Safety Recall: 26V380
June 2026

IMPORTANT SAFETY RECALL

Midwest Automotive Designs, a division of Alliance RV has decided that a defect which relates to motor vehicle safety exists in certain vehicles. Units impacted are select 2020 - 2026 Midwest Automotive Designs, a division of Alliance RV, Luxe Cruiser, Patriot Cruiser, Day Cruiser, Business Class, Professional Series, G-55, S-45, Athletic, Shuttle, Ultimate Coach, Ultimate Coach Executive, Ultimate Limo, Ultimate Cruiser, Ultimate Traveler, and Ultimate Weekender models. Affected units are those manufactured with a Xantrex Freedom XC 3000-Watt Inverter equipped with an undersized 2/0 AWG inverter negative battery cable.

Photo 4

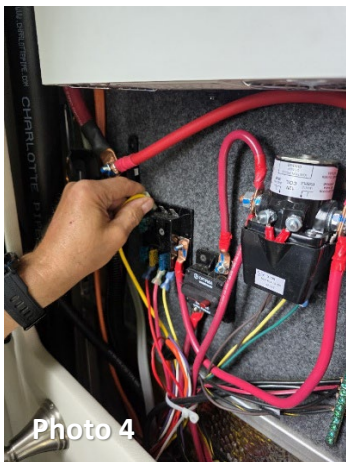
Locate the solar charge controller feed wire on the terminal block inside the lower inverter access door. Disconnect its female spade terminal to isolate solar power from the coach (Photo 4). Next, exit the coach and position yourself beneath the LR corner of the vehicle. Locate the 300-amp battery Mega fuse block mounted to the driver's side frame rail near the trailer hitch (Photo 5). Remove the protective cover, unbolt the nut securing the two stacked 4/0 red battery-positive cables, and clear them from the fuse block to completely isolate the underslung battery bank (Photo 6).

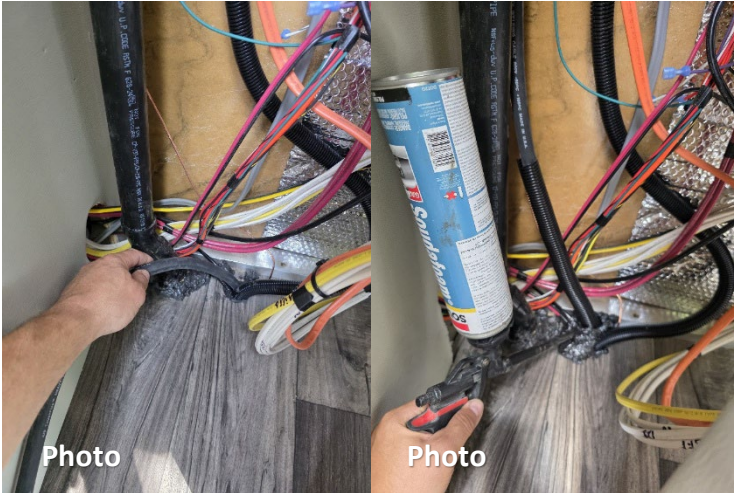
To expose the hidden factory cable routing, the rear bathroom workspace must be cleared. Unbolt and remove the interior toilet assembly from the floor and carefully set it aside outside the vehicle. Remove the fabric-covered screw caps and unscrew the rearmost driver-side corner wall panel next to the taillight assembly (Photo 7). Unscrew and remove the upper storage cabinet, disconnecting its integrated lighting wires at the Wago connectors (Photo 8). Next, unscrew the horizontal fasteners inside the inverter door frame and behind the plastic vents to slide back the false mechanical bulkhead wall. With the false wall moved out of the way, locate and remove the final hidden fasteners to completely remove the driver-side exterior wall panel behind the toilet, exposing the inner wall panel. This panel can remain in place (Photo 9).
